Review of Kimley-Horn Sediment Transport Model of the Agua Fria River

Prepared for:
Flood Control District of Maricopa County

WEST Consultants, Inc
2151 East Broadway Road, Suite 116
Tempe, AZ 85282

January 10, 2002

RS = 3.43

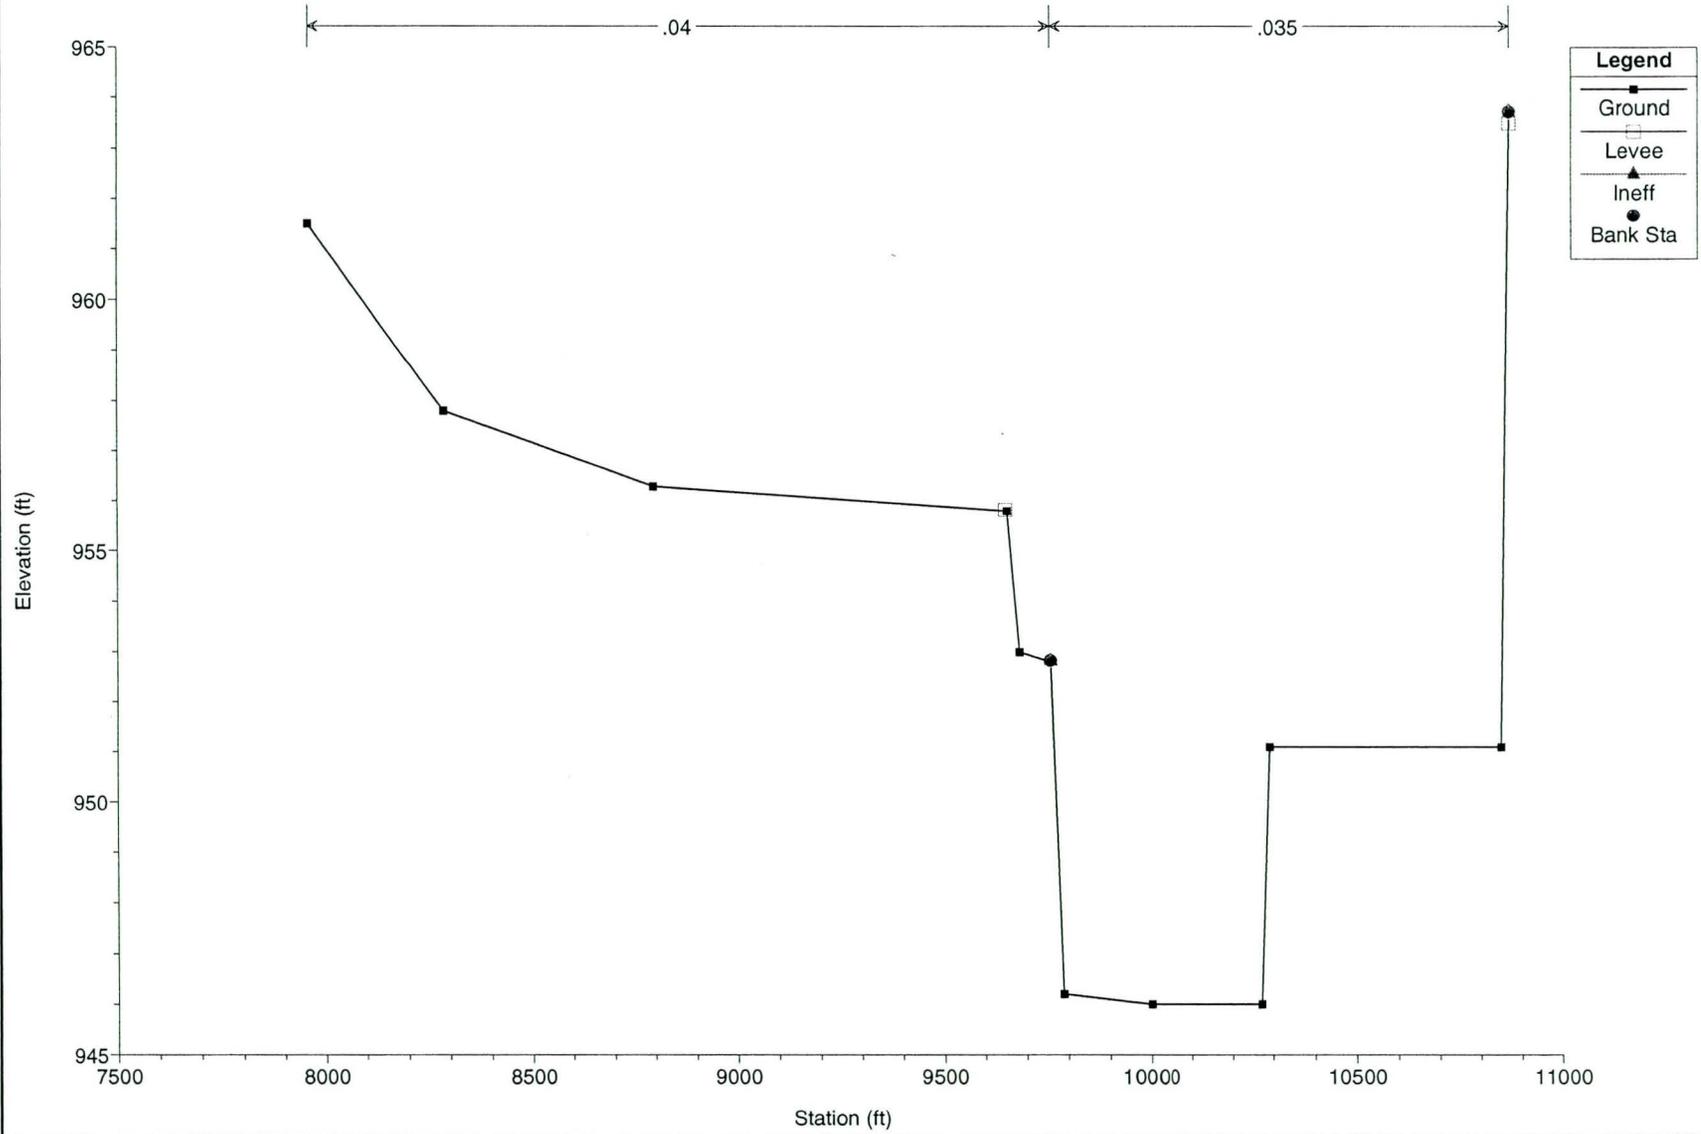
Significant expansion and contraction of the water surface width was noted at several cross sections (e.g. 1.33, 3.43, 15.374, 25.666, 32.92 as well as others). The expansion ratio should generally be limited to 3:1 (3 streamwise units to 1 lateral unit) and the contraction ratio should generally be limited to 1:1 by setting ineffective flow or conveyance limits (X3 or XL records) where appropriate. The cross sections listed above appear to be in violation of these recommendations.
